Manual Supplement

Manual Title: 381 Calibration
Part Number: Web Only
Print Date: December 2010
Revision/Date: 1, 6/12

Supplement Issue: **4**
Issue Date: 4/17
Page Count: 3

Figure 7. Current Test Simulated Voltage

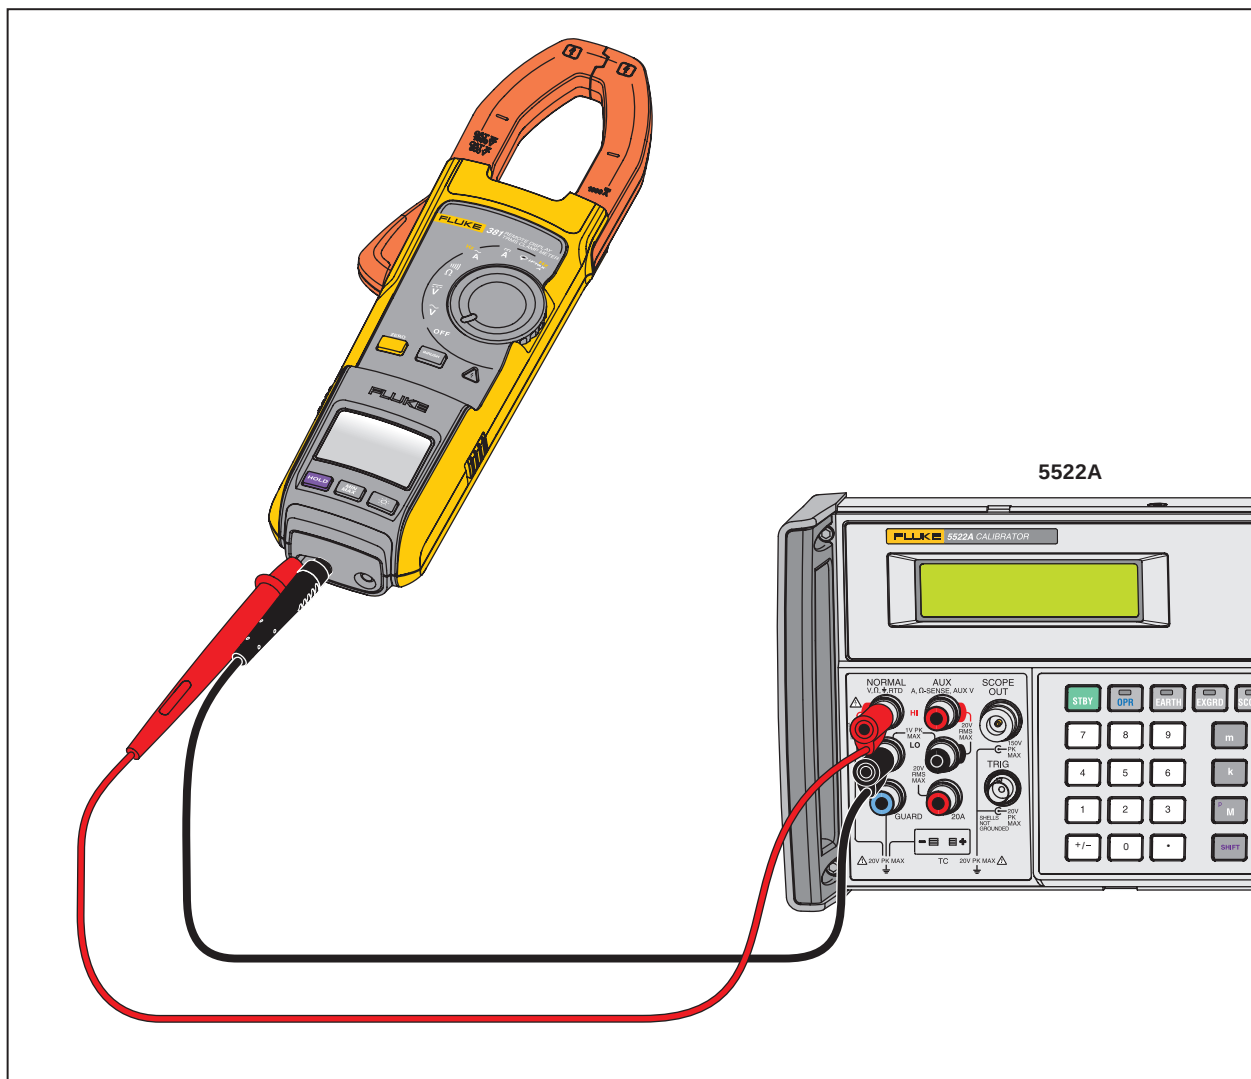
On page 14, replace Figure 7 with:

Figure 5. Performance Test Connections for AC Voltage, DC Voltage, and Frequency

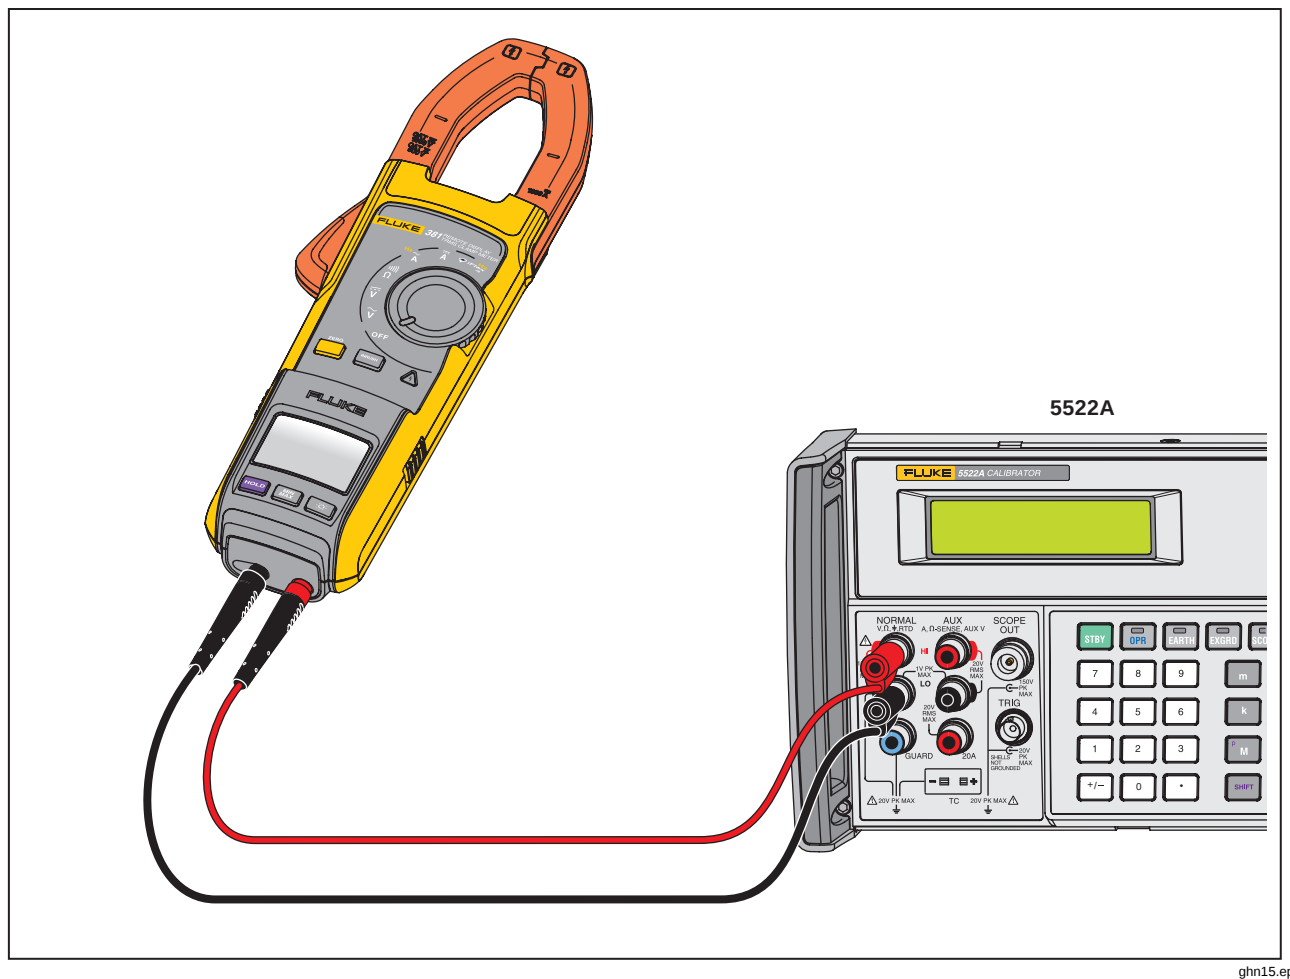
On page 10, replace Figure 5 with:
